Access Compliance Report

Public Rights-of-Way

(Curb Ramps)

Intersection ID: 6449	Main Street: FAIRES_FARM_RD	Cross Street: TERESA_JILL_DR	Location: NE
ADA ID: 506C152890E7	Ramp Type: Perp	Initial Pass/Fail: Pass	Overall Compliance: No
Codes/Mitigation Info/Possible Solution		Field Measurements/Component Compliance	
Severity Score: 12.5

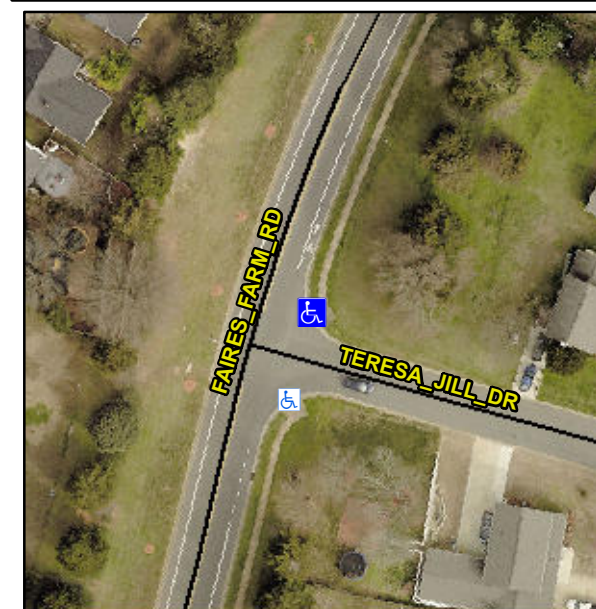
**Not Found, R304.2.1, R304.2.2-Perp,
R304.3.2-Para, R305.2, R302.7,
R302.7.2, R304.5.4**

Compliance	Description	Data	Compliance	Description	Data
N/A	Ramp Length (in)	60.0	Yes	Ramp Slope (%)	8.0
Yes	Ramp Width (in)	48.0	Yes	Ramp XSlope (%)	0.3
N/A	Flare Type LT	Sloped	N/A	Flare Type RT	N/A
N/A	Flare Slope LT (%)	13.3	N/A	Flare Slope RT (%)	8.3
N/A	Flare Traversable LT?	No	N/A	Flare Traversable RT?	No
No	Landing Length (in)	47.0	Yes	DWS Provided?	Yes
Yes	Landing Width (in)	48.0	Yes	DWS Contrast?	Yes
No	Landing Slope (%)	5.0	Yes	DWS Length (in)	24.0
Yes	Landing X Slope (%)	1.9	Yes	DWS Full Width?	Yes
N/A	Landing Curb? (Y/N)	No	No	DWS Offset (in)	2.5
N/A	Shared Landing?	No			
No	Gutter Ponding?	Yes	No	Gutter Slope (%)	5.9
No	Gutter Lip Ht (in)	0.5	Yes	Gutter X Slope (%)	0.6
N/A	Painted X Walk1?	No	N/A	Painted X Walk2?	N/A
	X Walk 1 Direction	To S		X Walk 2 Direction	N/A
N/A	X Walk 1 Width (in)	N/A	N/A	X Walk 2 Width (in)	N/A
	X Walk 1 Slope (%)	2.5		X Walk 2 Slope (%)	N/A
	X Walk 1 X Slope (%)	1.1		X Walk 2 X Slope (%)	N/A

N/A	Ramp inside XWalk1?	N/A	N/A	Ramp inside XWalk2?	N/A
	Road Slope (%)	N/A	N/A	Clear Space?	Yes
	Road X Slope (%)	N/A	N/A	Clear Space to XWalk (in)	N/A
Yes	Any Obstructions?	No	Yes	Storm Grate/Utility Hazard?	No
	Obstruction Type			Storm Grate/Utility Type	
		N/A			N/A
			Yes	Surface Condition? (G/P)	Good

**Remove & Replace Entire Ramp.
Remove & Replace Gutter.**
